Re: **Addendum # 1**
SEABREEZE SHORE REMEDIATION PROJECT
NJDEP - DIVISION OF COASTAL ENGINEERING
PROJECT NUMBER 4248-13

NJDEP Project #4248-13
Seabreeze Shore Remediation Project
Addendum #1: (Q&A) - 9/4/2020

APPENDIX AD1-2

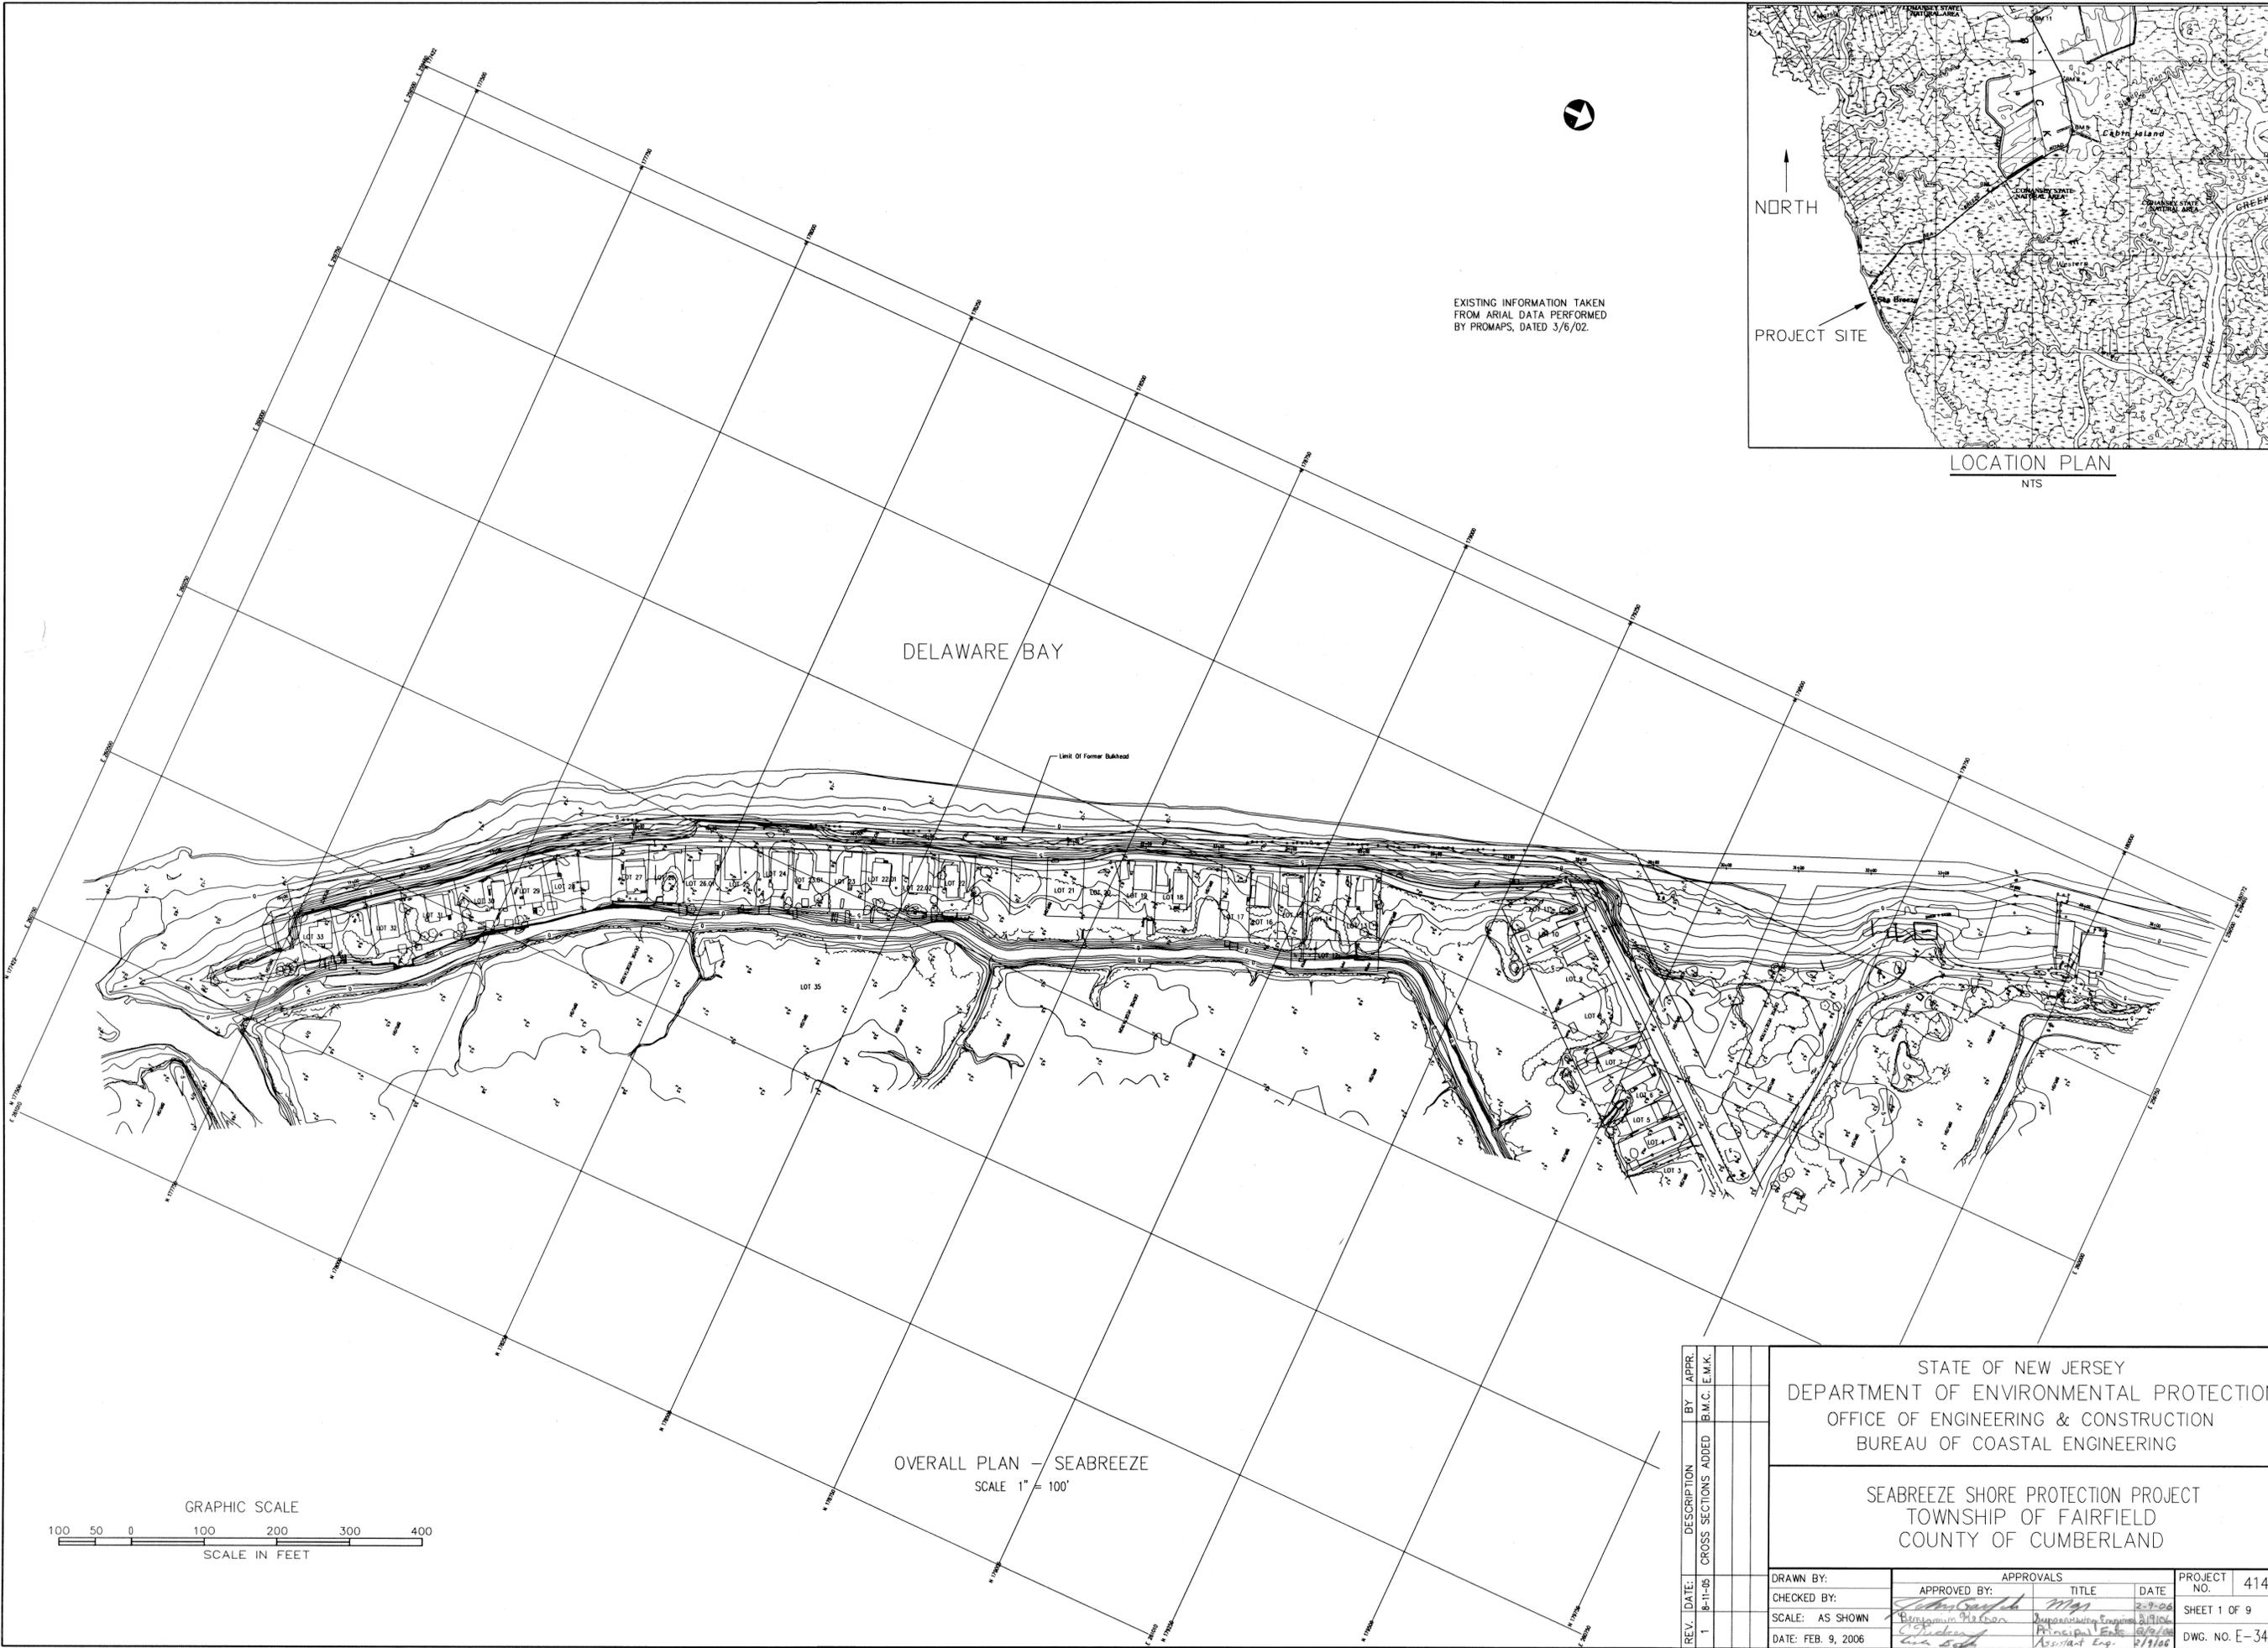
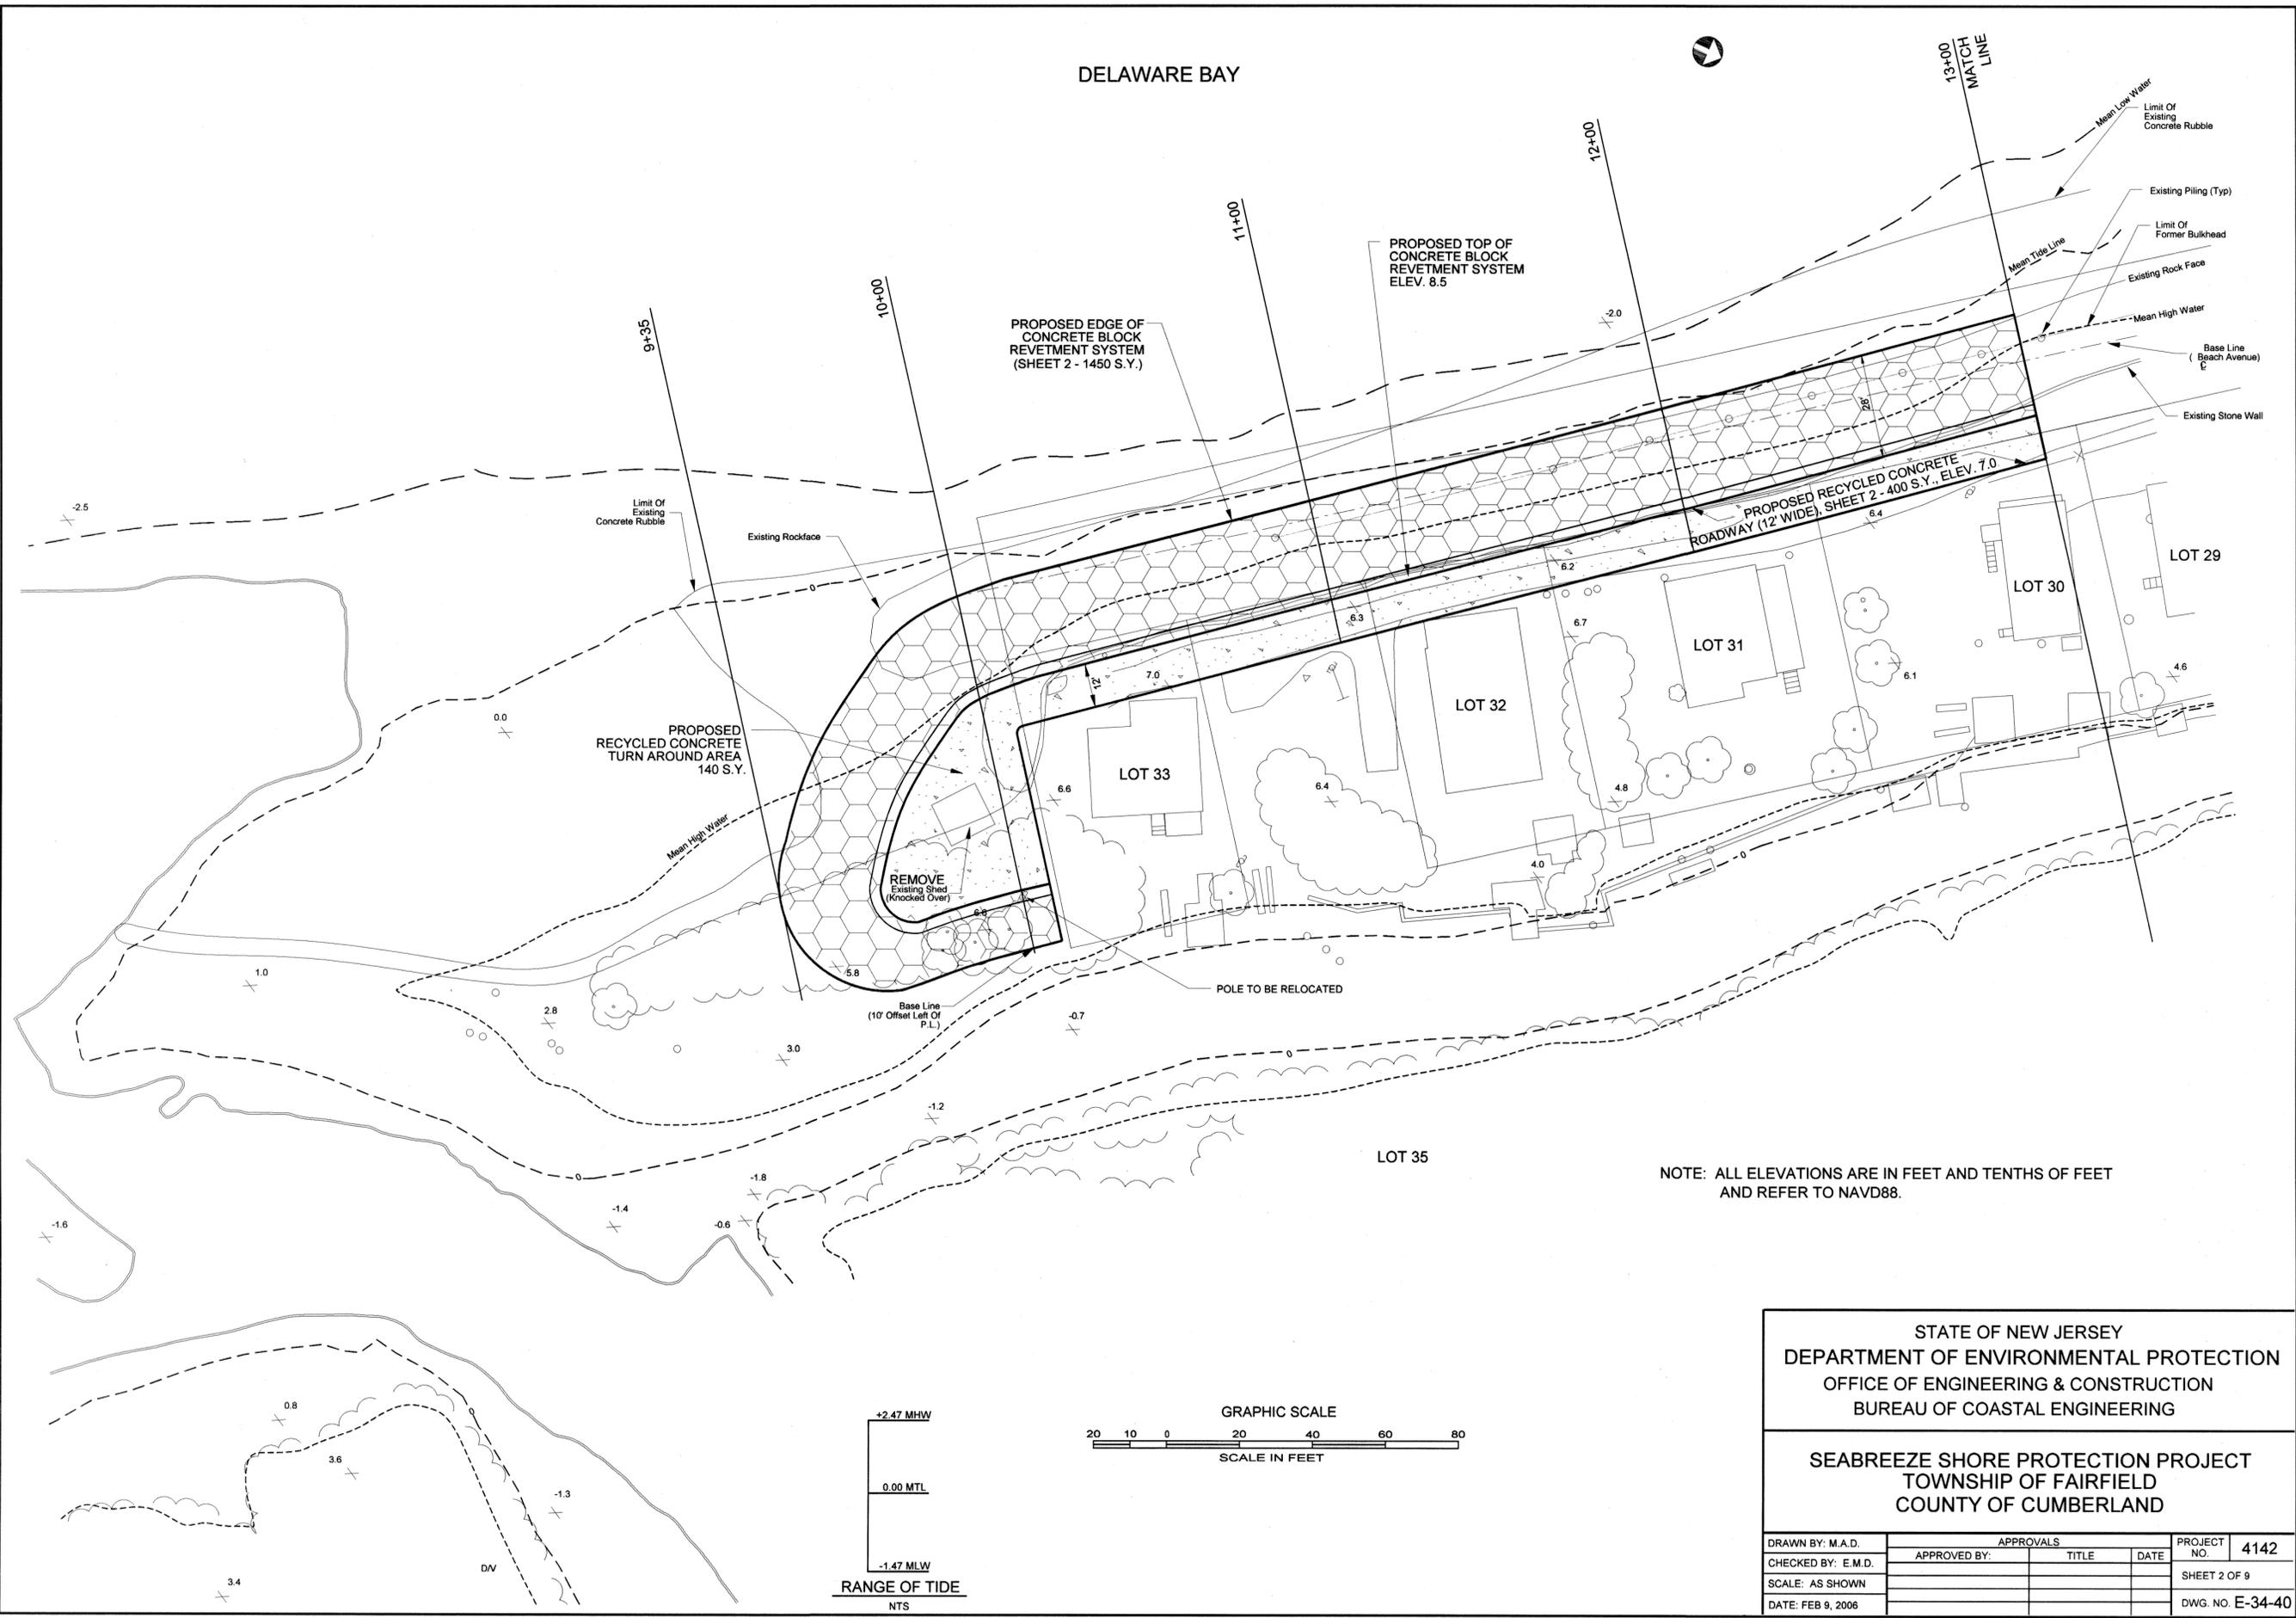
12. How much of the revetment is being left and buried?

A: The only portion of the revetment to remain and be covered with sand is at the turnaround area at the south end of the project (see plans for further detail). All other sections shall be fully removed, inclusive of the toed-in blocks (see Appendix AD1-2, Original Construction Drawings).
